Wheel Horse

Service Bulletin

13

SUBJECT: RMR 32-60 ROTARY MOWER

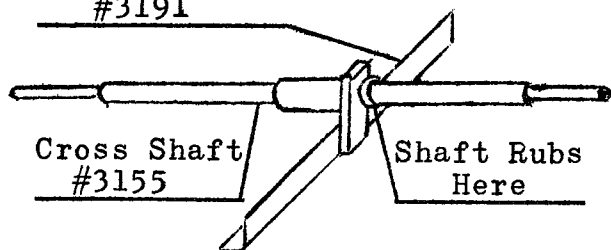
In cases of excessive belt wear of the 30" belt on the rotary mower, a check should be made to be sure that the tube, guard mount, part #3182 is not rubbing on the belt. In the event it is rubbing, a new part #3709 is available at no charge, which will rectify this problem. It should be installed as shown in the cutaway view and be adjusted by turning the bolt so that there is 1/8" clearance with the mower belt engaged (TIGHT) and the lift lever all the way back.

RH Mounting
Angle Assembly
#3191

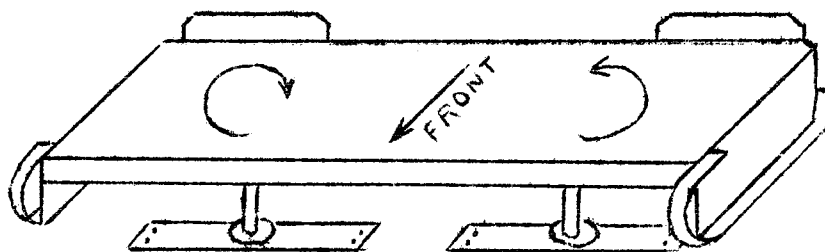
NOTE: The RH Mounting angle assembly, part #3191, in some cases rubs against the cross shaft, #3155, and causes friction.

A few drops of oil will usually rectify this problem, but in the event of excessive friction, part #3191 will be replaced under warranty.
